RE: **Dunkin' Donuts**  
**4208 Central SW**  
**Grading Plan Stamp Date: 7/26/19**  
**Hydrology File: K12D015D**

Based on the submittal received on 8/22/19, this project cannot be approved until the following corrections are made:

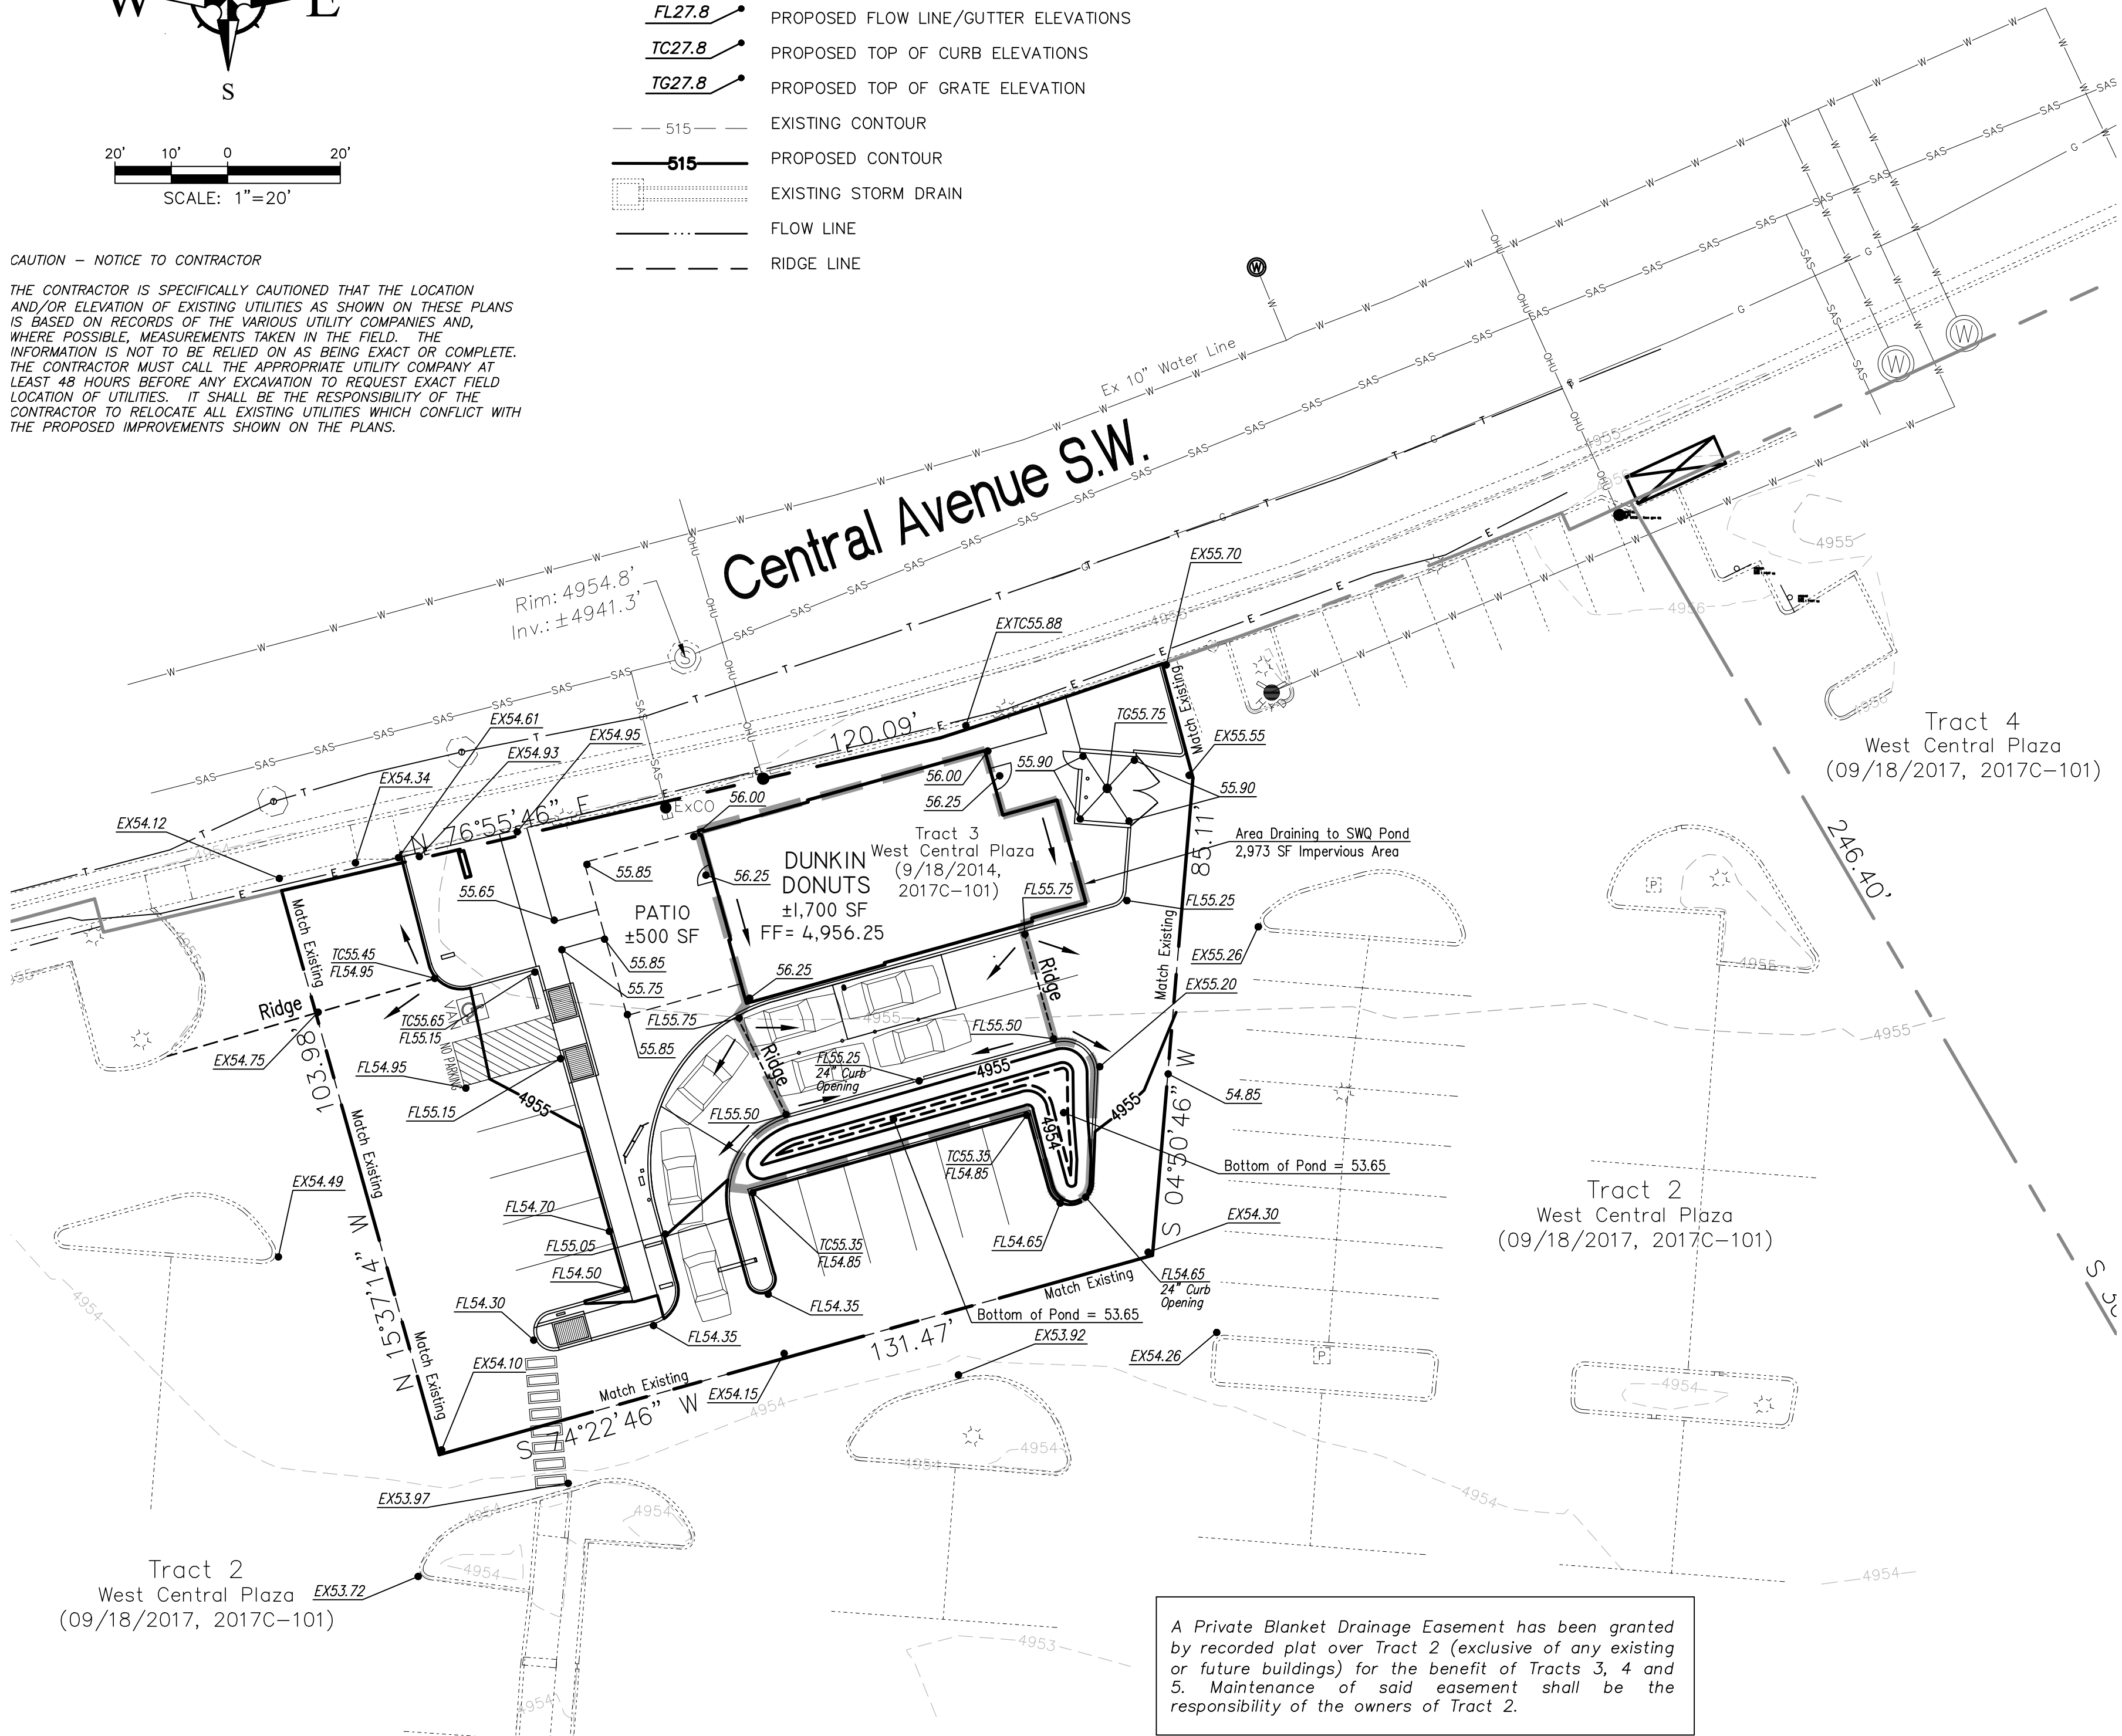
1. Payment in Lieu (Amount =  $199\text{cf} \times \$8/\text{cf} = \$1592$ , per sheet C2.1) of onsite management of the SWQ bypass volume must be made. Provide a copy of the paid receipt with a new DTIS form requesting building permit approval once paid (there is no resubmittal fee for this activity).
